Access Compliance Report

Public Rights-of-Way

(Curb Ramps)

Intersection ID: 16115	Main Street: MARVIN_RD	Cross Street: VILLA_CT	Location: NE
ADA ID: F45587C82021	Ramp Type: PerpDiag	Initial Pass/Fail: Fail	Overall Compliance: No
Codes/Mitigation Info/Possible Solution		Field Measurements/Component Compliance	
Severity Score: 21.25

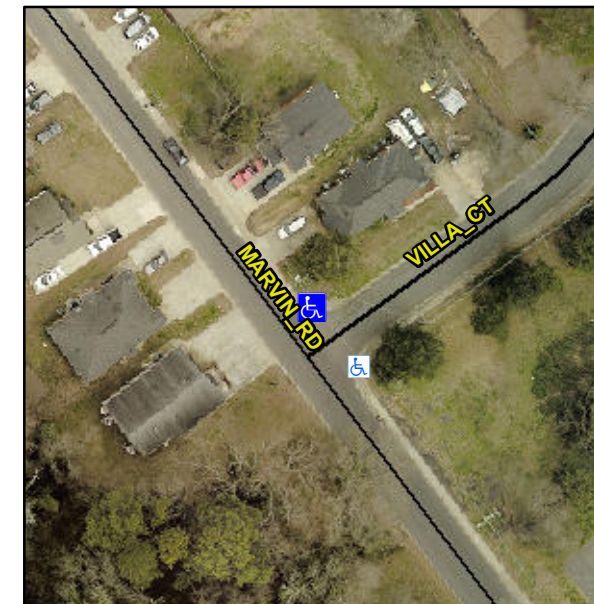
Not Found, R304.5.1, R304.2.2

Compliance	Description	Data	Compliance	Description	Data
N/A	Ramp Length (in)	28.0	No	Ramp Slope (%)	8.8
No	Ramp Width (in)	44.0	Yes	Ramp XSlope (%)	2.0
N/A	Flare Type LT	N/A	N/A	Flare Type RT	N/A
N/A	Flare Slope LT (%)	N/A	N/A	Flare Slope RT (%)	N/A
N/A	Flare Traversable LT?	N/A	N/A	Flare Traversable RT?	N/A
N/A	Landing Length (in)	N/A	N/A	DWS Provided?	N/A
N/A	Landing Width (in)	N/A	N/A	DWS Contrast?	N/A
N/A	Landing Slope (%)	N/A	N/A	DWS Length (in)	N/A
N/A	Landing X Slope (%)	N/A	N/A	DWS Full Width?	N/A
N/A	Landing Curb? (Y/N)	N/A	N/A	DWS Offset (in)	N/A
N/A	Shared Landing?	N/A			
N/A	Gutter Ponding?	N/A	N/A	Gutter Slope (%)	N/A
N/A	Gutter Lip Ht (in)	N/A	N/A	Gutter X Slope (%)	N/A
N/A	Painted X Walk1?	No	N/A	Painted X Walk2?	No
	X Walk 1 Direction	To SW		X Walk 2 Direction	To SE
N/A	X Walk 1 Width (in)	N/A	N/A	X Walk 2 Width (in)	N/A
	X Walk 1 Slope (%)	0.9		X Walk 2 Slope (%)	4.0
	X Walk 1 X Slope (%)	0.4		X Walk 2 X Slope (%)	1.6

Remove & Replace Curb Ramp With Two New Directional Ramps or Equivalent.
